HISTORIC AND DESIGN REVIEW COMMISSION

HDRC CASE NO: 2023-351
ADDRESS: 3853 N ST MARYS ST
LEGAL DESCRIPTION: NCB A49 PART OF A-2, A-4, A-52 (208 AC)
ZONING: R-5, HL
CITY COUNCIL DIST.: 2
APPLICANT: James Torres/Don B. McDonald Architects
OWNER: CITY OF SAN ANTONIO
TYPE OF WORK: New construction of a 2-story restroom structure
APPLICATION RECEIVED: August 18, 2023
60-DAY REVIEW: October 17, 2023
CASE MANAGER: Rachel Rettaliata

The applicant is requesting a Certificate of Appropriateness for approval to construct a 738-square-foot, 2-story restroom structure.

1 Site Plan

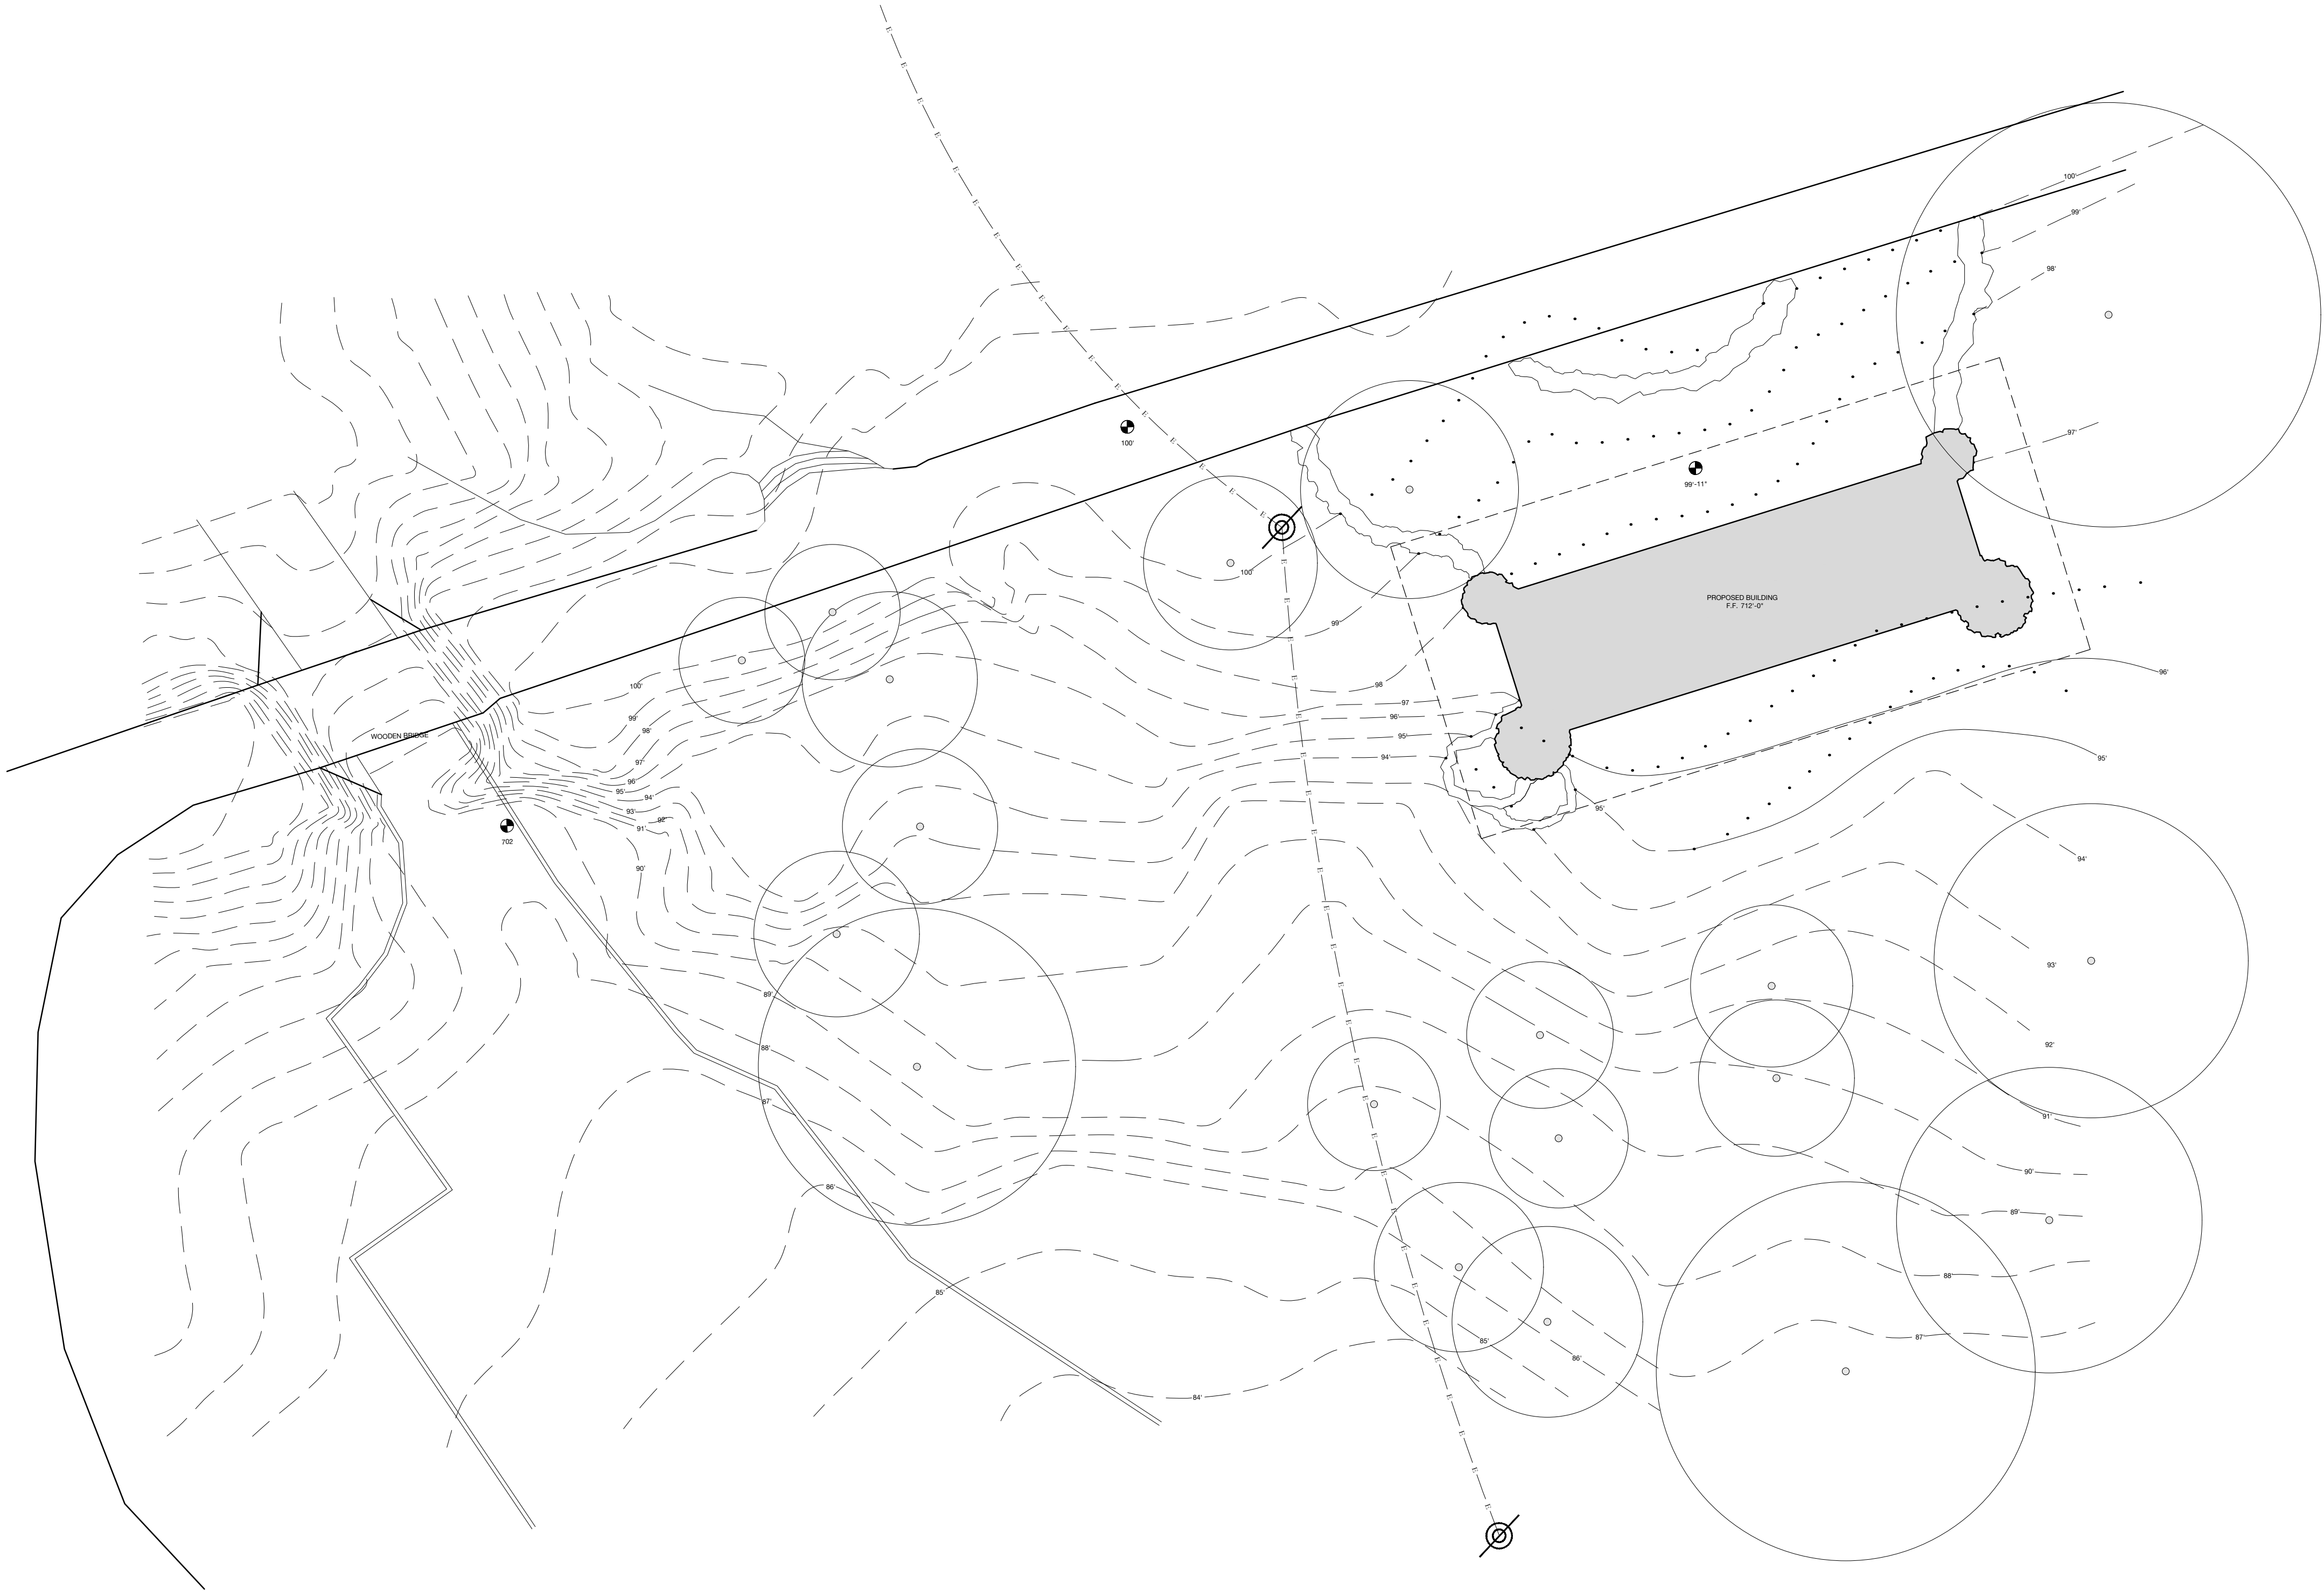
MS: On the other file, I had problems finding the site on the site plan. You may want to consider an updated site plan.

JF: A different scale where you show this in relation to the Jingu House.
